Thank you for the opportunity to review the concept plan, for the (Takoma Junction development – SHA Tracking #19-AP-MO-008-xx) in Montgomery County, Maryland. The State Highway Administration (SHA) review is complete, and we are pleased to respond.

Engineering Systems Team (EST) Comments (By: Urooj Zafar):

Figure 9-17. Departure Sight Triangles for Intersections

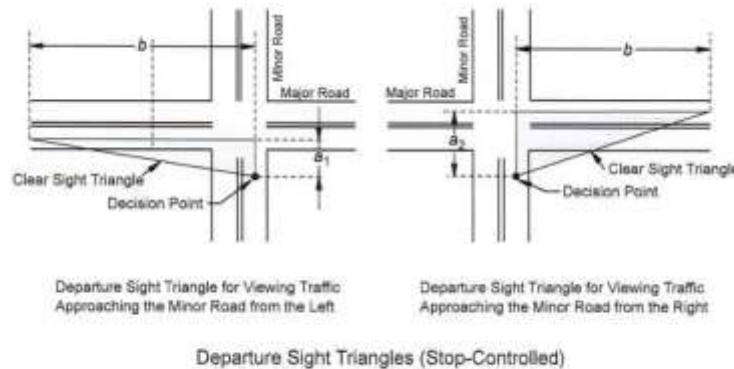
- The sight distance measurements were not conducted in accordance with professional standards of practice as specified by the American Association of State and Highway Transportation Officials (AASHTO). Please refer to the AASHTO Green Book for the appropriate methodology. The Institute of Transportation Engineers Manual of Transportation Engineering Studies and the Traffic Engineering Handbook provide additional guidance. Sight distance identified as dimension b below (for intersection sight distance), is measured as part of an intersection sight triangle with a decision point located 14.5 feet from the edge of the major road traveled way. Figure 9-17 from the AASHTO Green Book copied below illustrates.
 - Sightlines are measured along a straight line
 - Sightlines do not curve with the vehicle path
 - Sightlines do not curve around objects

Related object heights are as indicated in the Manual. Please revise accordingly.
